**Response to Comments and Addendum to the SMC OU2 Supplemental  
Remedial Investigation Workplan Deliverables**

**Response to Comments and Addendum to the OU2 HHRA Conceptual Site Model & Memorandum of Exposure Scenarios and Assumptions-Human Health Risk Assessment**

**Response to Comments on the Quality Assurance Project Plan (QAPP)**  
**OU2 Supplemental Remedial Investigation (including Baseline**  
**Ecological Risk Assessment)**

<b>TRC ENVIRONMENTAL CORP.</b> 57 East Willow Street Millburn, New Jersey 07041		
VANADIUM SOIL SAMPLING RESULTS		
SHIELDALLOY METALLURGICAL CORPORATION NEWFIELD, NEW JERSEY		
JOB NO.: 2710ES-112434		
JG/LB	DATE: AUGUST 2011	FIGURE:

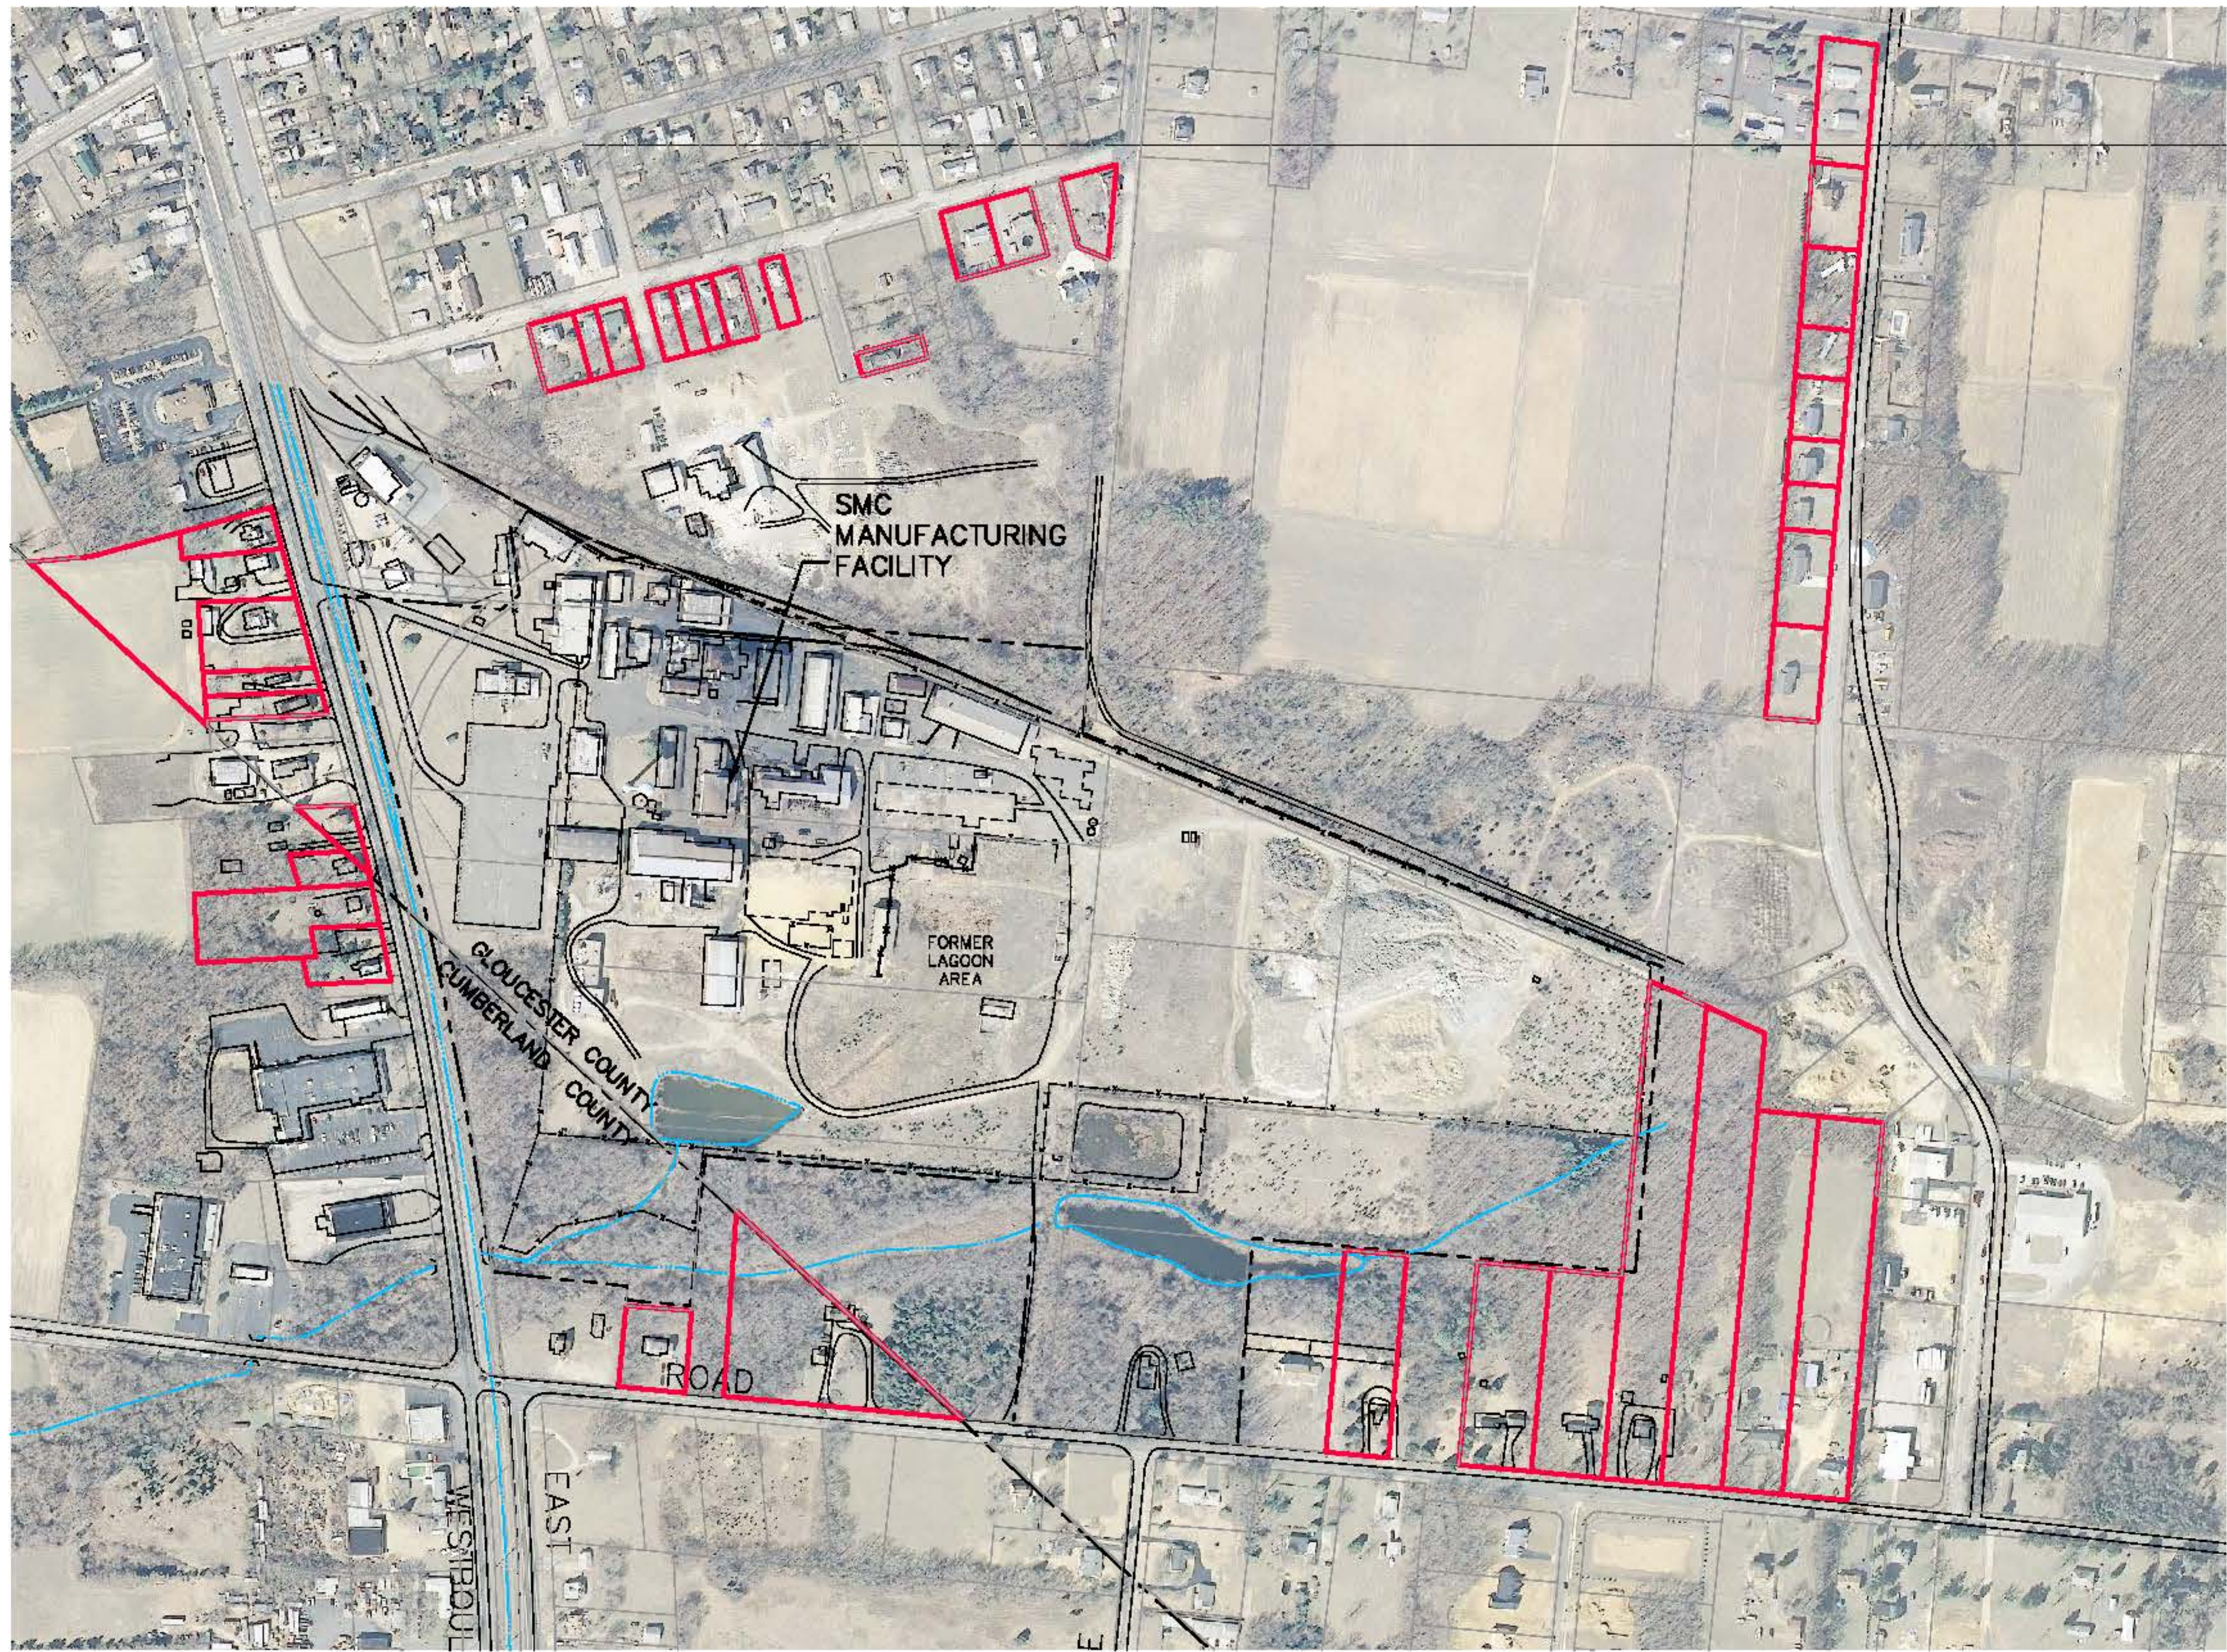
**Comment:** Please ensure that all that the most recent screening level tables are being utilized in the Report. The most recent EPA Regional Screening Level Table (June 2011, is available at: [http://www.epa.gov/reg3hwmd/risk/human/rb-concentration-table/Generic-Tables/pdf/master\\_sl\\_table\\_run\\_JUN2011.pdf](http://www.epa.gov/reg3hwmd/risk/human/rb-concentration-table/Generic-Tables/pdf/master_sl_table_run_JUN2011.pdf) . The value presented for Vanadium is not correct.

**Comment:** Four surface soil samples are proposed (SB-84 through SB-87) along the northern property line. It may be necessary to include a fifth location north of building D203D to delineate data gap in this area where no samples have previously been collected.

**Response:** TRC is aware that these tables were published shortly after we prepared and submitted our documents. We have prepared a revised Figure 8, which is included herein as part of the addendum.

**Response:** The samples were proposed to help delineate Vanadium. Because the Vanadium screening level has changed since the OU2 document submission, there are fewer. See revised Figure 8. Based on these revisions, TRC feels that sampling along this area is no longer necessary and proposes to delete it from the workplan.

**Response:** Based on the most recent EPA Regional Screening Level Table (June 2011), vanadium is no longer an exceedance for soil samples near the facility property line and proposed sample SB-95. Please see the revised Figure 8. Proposed sample SB-95 will be moved closer to sample SS-5 to delineate the horizontal extent for chromium at this location. The location for proposed sample SB-95 is shown on the revised Figure 15 (Proposed Soil Sample Locations).
